WORK PLAN ADDENDUM I
RCRA FACILITY INVESTIGATION
VAN WATERS & ROGERS, INC.
3950 NW YEON AVENUE
PORTLAND, OREGON

HLA Job No. 9695,105.02

March 6, 1989

**Soil Gas Extraction and Monitoring Well
Construction Diagram**
Work Plan Addendum I
Van Waters & Rogers, Inc.
Portland, Oregon

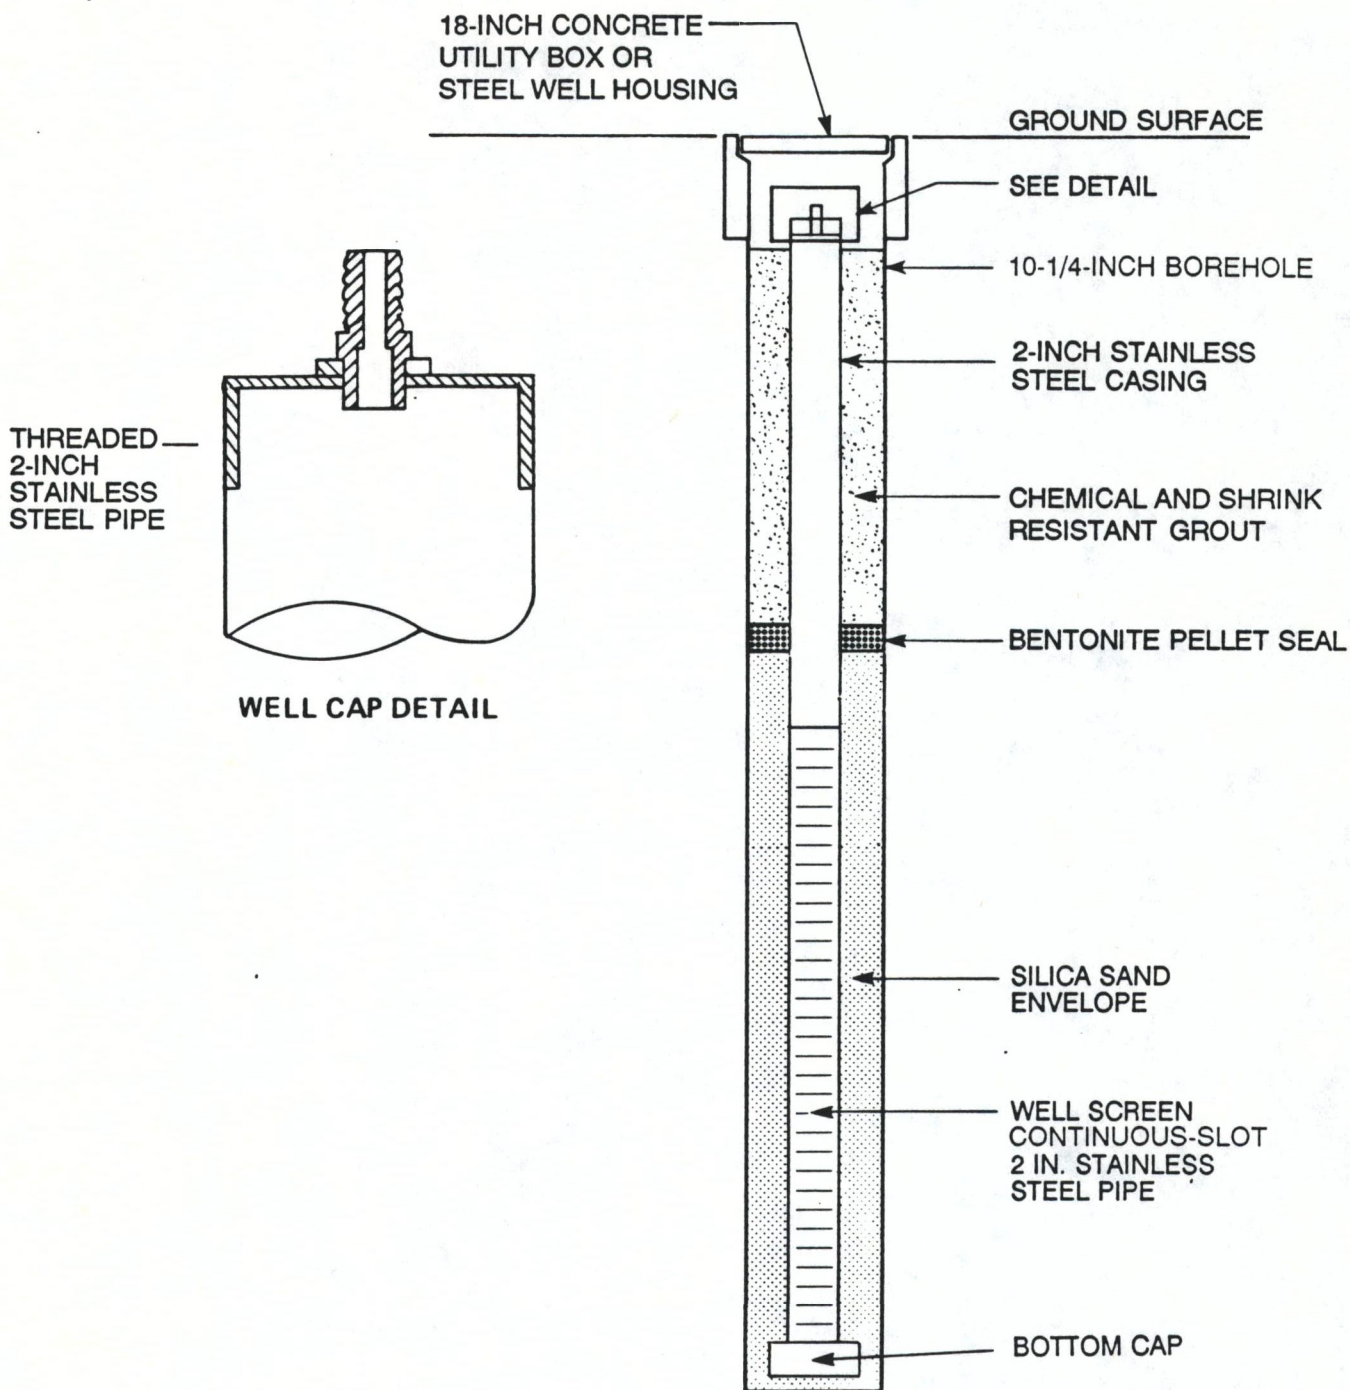
Boring DB-19 will be cased with 2-inch diameter stainless steel casing and screen for possible use as a soil gas monitoring well. The completion details for a soil gas monitoring well are shown on Plate 7. Construction procedures are similar to those specified for construction of single-cased wells in Section 5.4.1 of the DCQAP.

The well screen will be set in the boring from 1 to 2 feet above the water table to approximately 2.5 feet below ground level. A sand pack will be placed adjacent to

A 1-foot-thick bentonite pellet seal will be placed above the sand pack. Water will then be added to the pellets to cause the pellets to expand and create a tight annular seal.

The annulus above the bentonite seal will be grouted with a shrink- and chemical-resistant cement-bentonite grout. The top of the casing will be threaded to accept an air-tight cap with a hose connection to facilitate sampling. The well will be completed below grade using a steel well housing with a locking cover set in the annular seal. The soil gas monitoring well will be sampled following procedures outlined in the DCQAP.

Borings DB-22, DB-23, and DB-24 will be cased with 2-inch-diameter stainless steel casing and screen for possible use as soil gas extraction wells. Soil gas extraction well construction details are shown on Plate 7. Construction procedures are similar to those described for construction of single-cased wells in Section 5.4.1 of the DCQAP.

The well screen will be set in the boring from 1 to 2 feet above the water table to approximately 5 feet below ground level. A sand pack will be placed adjacent to the entire screened interval and will extend approximately 6 inches above the top of the screen.

The annulus above the bentonite seal will be grouted with a shrink- and chemical-resistant cement-bentonite grout. The top of the casing will be threaded to

accept an air-tight cap. The well will be completed below grade using 18-inch reinforced concrete utility boxes.
